**RE: PROJECT #P12479 STORMSTATION 2 FIXED EMERGENCY GENERATOR**

In summary, the DDA requests that the location of the proposed Stormstation 2 Fixed Emergency Generator be moved to the location shown in the attached site plan (Exhibit 1), closest to the southern edge of the SE 1<sup>st</sup> Avenue cul de sac. With this relocation, the DDA confirms our intent to pay for the additional design and construction costs that are determined to be reasonable and necessary. Further, the DDA requests that the City and its generator contractor continue to work in good faith with the DDA and the Huizenga Park contractor to complete these two projects in a manner and schedule that expedites completion and minimizes impacts to each party and project.

**Huizenga Park**  
 Fort Lauderdale, Florida  
 September 7, 2023

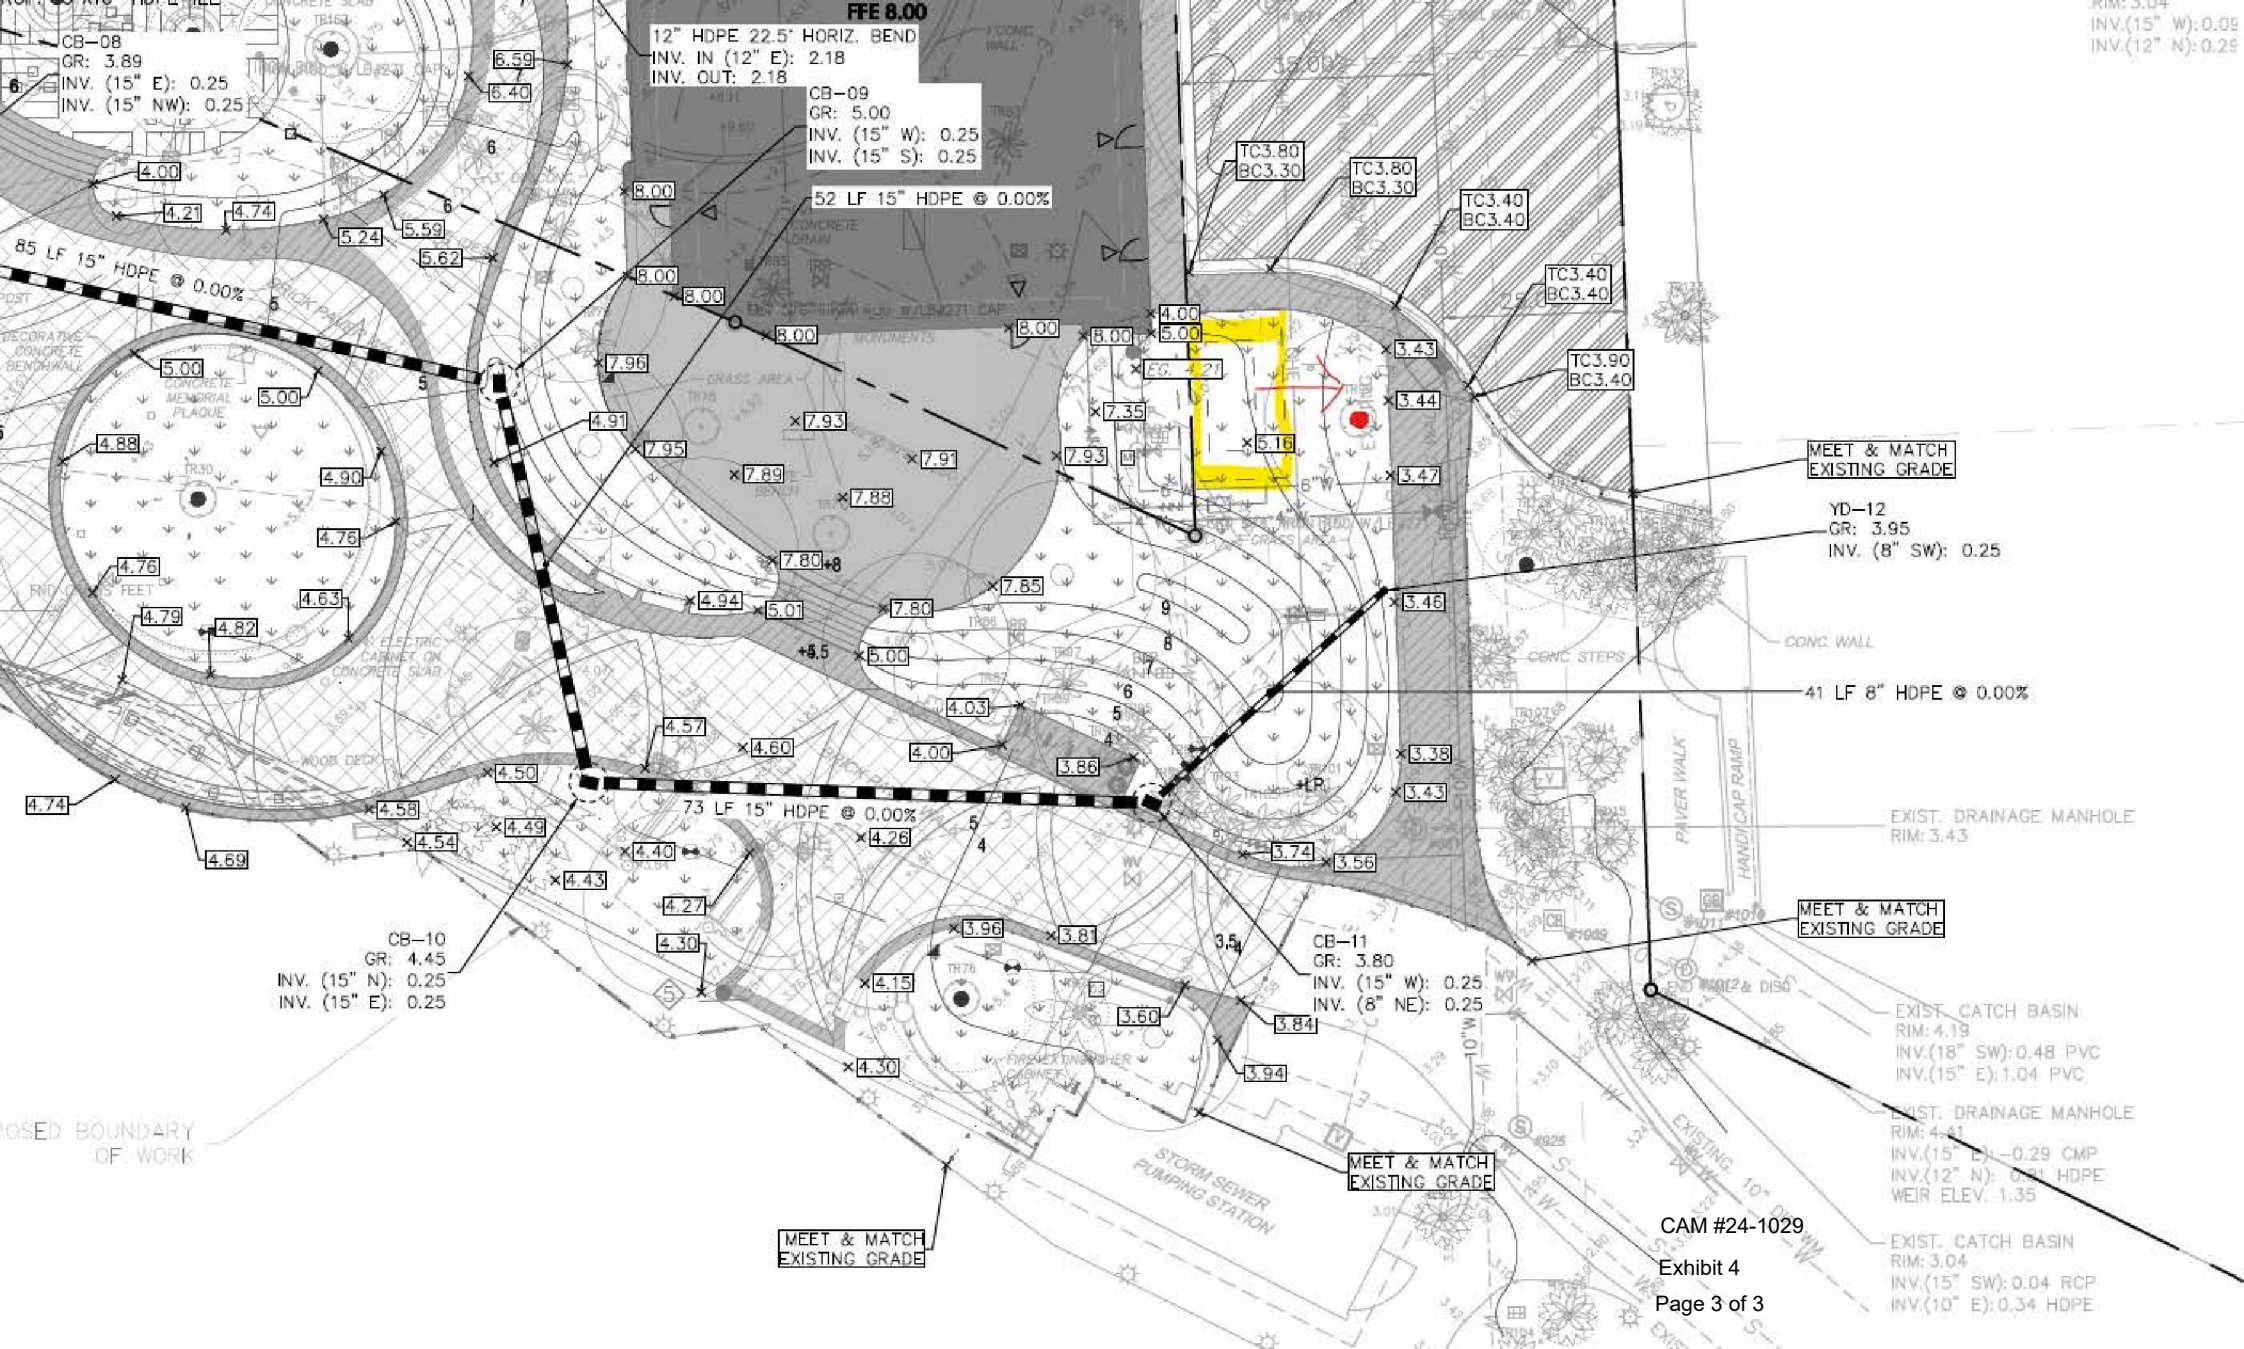
It is the desire of the DDA that the generator be sited in an area that has the least negative visual and physical impact to the proposed Huizenga Park plan, including the location of the approved outdoor dining terrace along the Riverwalk. Exhibit 2 is a plan excerpt that further illustrates the proposed design of Huizenga Park with the revised site elevations and shows how the generator could be shifted further east if an existing tree were to be removed.
